SUNDRY NOTICES AND REPORTS ON WELLS
Do not use this form for proposals to drill or to re-enter an abandoned well. Use form 3160-3 (APD) for such proposals.

8. Well Name and No.
COACHWHIP 26 FEDERAL 1H

Devon Energy Production Company, L.P. respectfully requests to change the approved APD as follows:

DRILLING PROGRAM

PRIMARY MODE

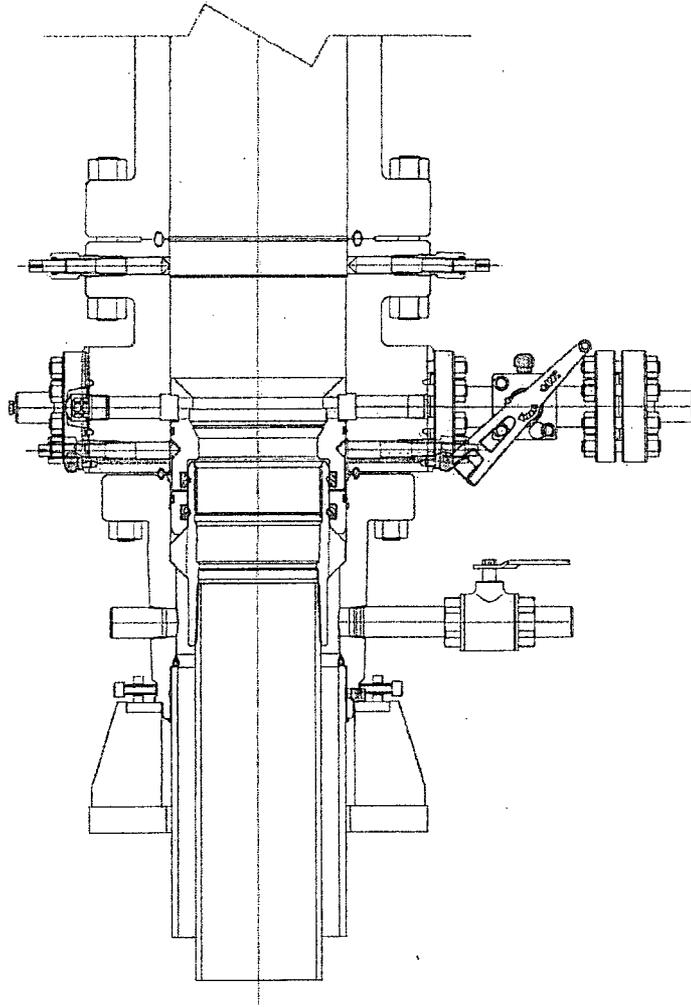
Devon proposes using a multi-bowl wellhead assembly (FMC Uni-head). This assembly will only be tested when installed on the surface casing. Minimum working pressure of the blowout preventer (BOP) and related equipment (BOPE) required for drilling below the surface casing shoe shall be 3000 (3M) psi.

- Wellhead will be installed by FMC's representatives.
- If the welding is performed by a third party, the FMC's representative will monitor the temperature to verify that it does not exceed the maximum temperature of the seal.

- FMC representative will install the test plug for the initial BOP test.
- FMC will install a solid steel body pack-off to completely isolate the lower head after cementing intermediate casing. After installation of the pack-off, the pack-off and the lower flange will be tested to 5M, as shown on the attached schematic. Everything above the pack-off will not have been altered whatsoever from the initial nipple up. Therefore the BOP components will not be retested at that time.

3. **Operator has proposed a multi-bowl wellhead assembly. This assembly will only be tested when installed on the surface casing. Minimum working pressure of the blowout preventer (BOP) and related equipment (BOPE) required for drilling below the surface casing shoe shall be 3000 (3M) psi.**

- a. **Wellhead shall be installed by manufacturer's representatives, submit documentation with subsequent sundry.**
 - b. **If the welding is performed by a third party, the manufacturer's representative shall monitor the temperature to verify that it does not exceed the maximum temperature of the seal.**

- c. **Manufacturer representative shall install the test plug for the initial BOP test.**
 - d. **Operator shall perform the intermediate casing integrity test to 70% of the casing burst. This will test the multi-bowl seals.**

FMC Technologies
DRAWING NUMBER
DM100161771-2B

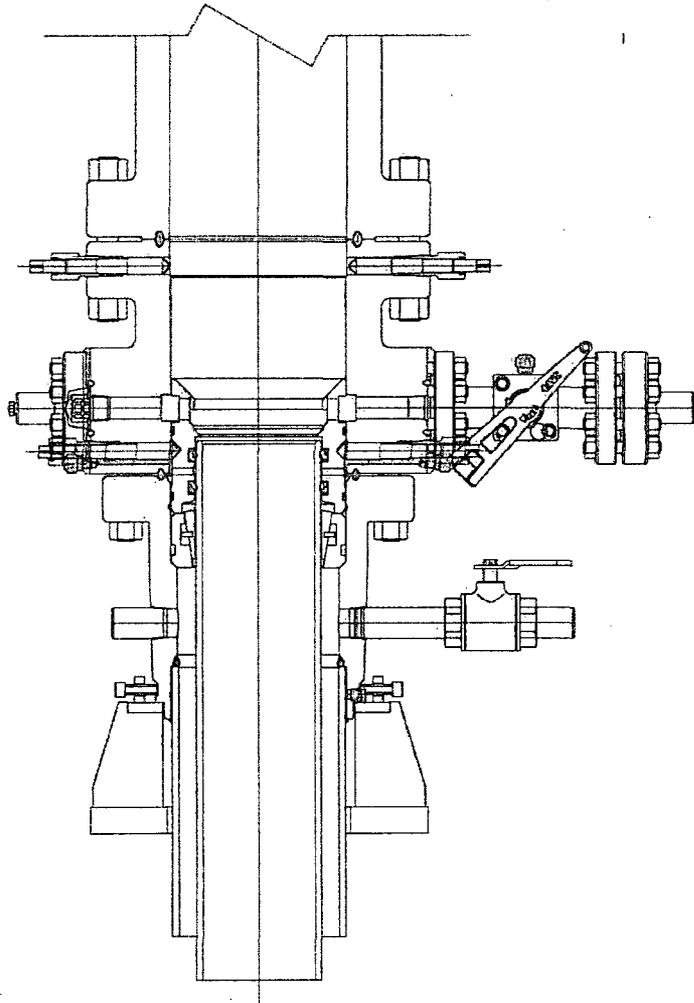
- If the cement does not circulate and one inch operations would have been possible with a standard wellhead, the well head will be cut and top out operations will be conducted.

- e. **If the cement does not circulate and one inch operations would have been possible with a standard wellhead, the well head shall be cut off, cementing operations performed and another wellhead installed.**
